### NEEDHAM PLANNING BOARD

### Tuesday November 16, 2021 7:00 p.m.

7:20 p.m. Amendment to Major Project Site Plan Special Permit No. 2009-06: Town of Needham, 1471

8:30 p.m. Major Project Site Plan: Needham Enterprises, LLC, 105 Chestnut Street, Suite 28, Needham,

SHEET 1 OF 9

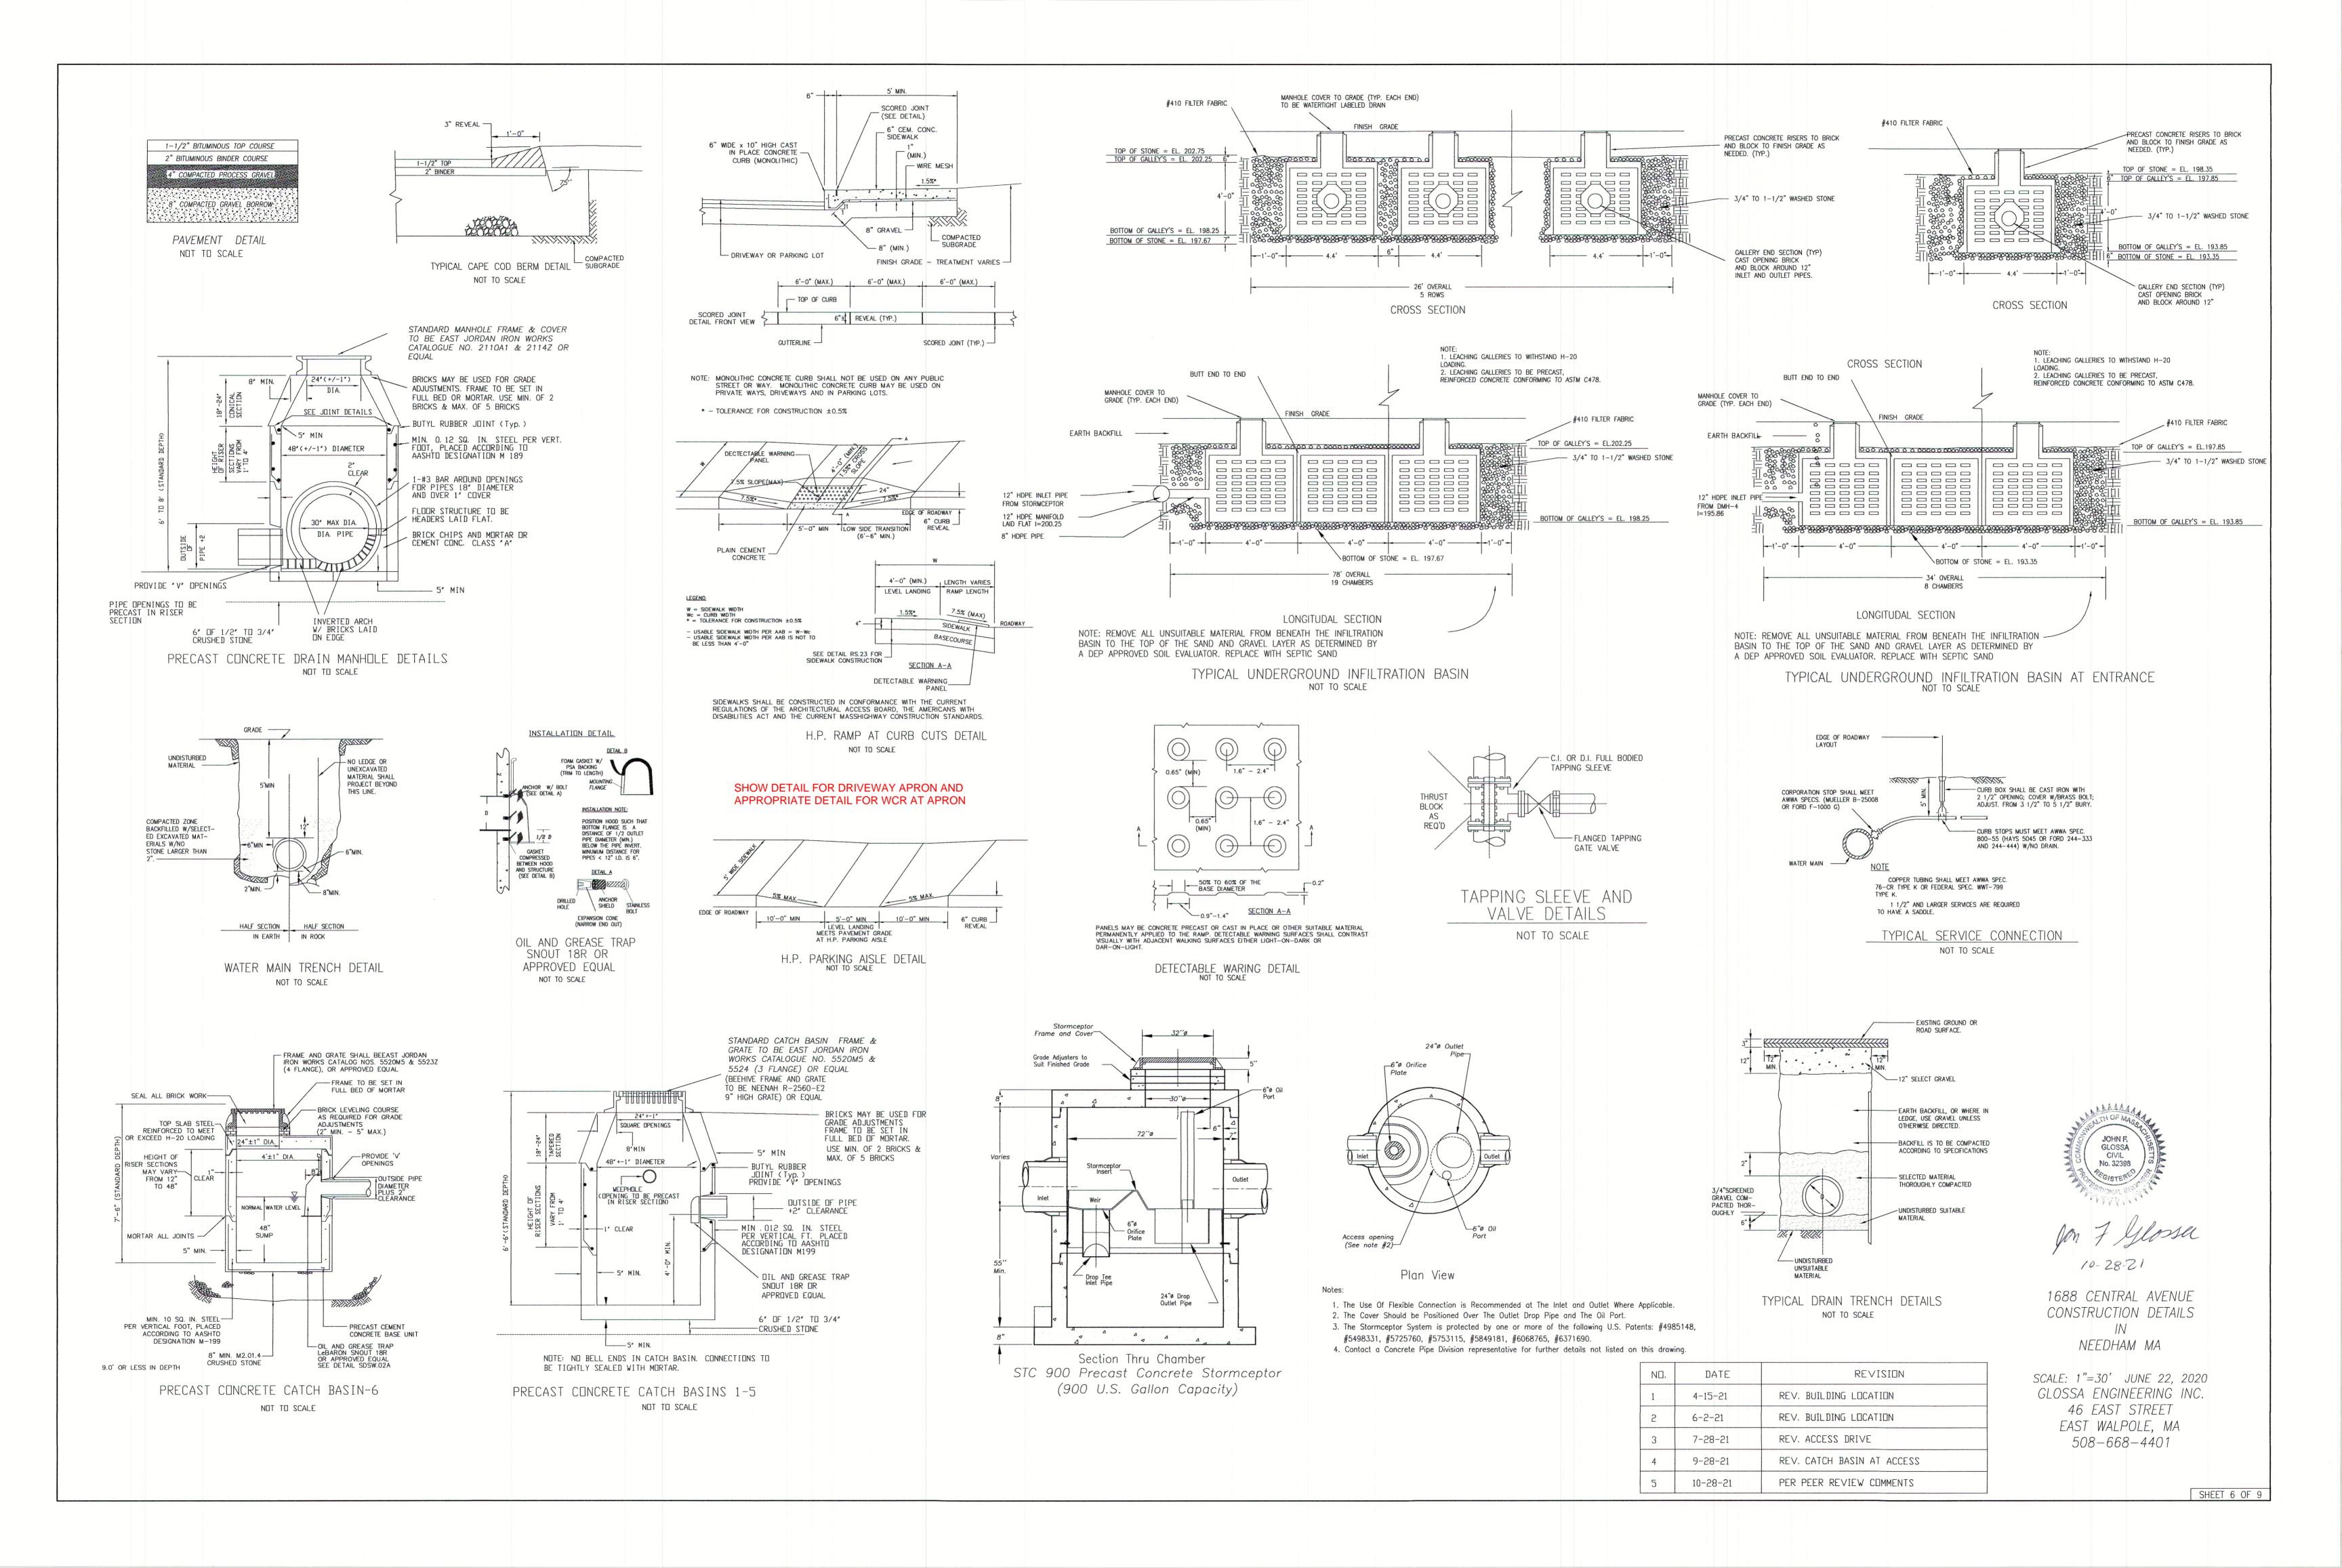
- a) Sheet 4 Proposed grades of the centerline of the driveway apron do not make sense. It appears to slope DOWN from the edge of road to the front of crosswalk by more than 2% and then slope up to the back of the crosswalk by more than 4%

- b) <u>Sheet 4 The spot grades 200x68 and 200x74 indicate the apron slope of about 1% UP at the sidewalk openings and a 1.8%-2.0% slope across the sidewalk/crosswalk, the apron portion should be sloped greater than the crosswalk portion.</u>

- c) Provide grades on sidewalk approaching driveway. It is unclear if the sidewalk slopes to the driveway or is level with the crossing.
- d) Sheet 4 Limit of work on the sidewalks should be indicated (also relates to Comment 2)

- e) Sheet 6 Detail should be provided for the proposed driveway apron.
- Sheet 8 & 9 Proposed CBs should be labeled and Existing CB to be removed should be labeled

- g) Sheet 10 Either delete labels on CBs (not relevant for lighting) or correctly label the Existing CB to be Removed
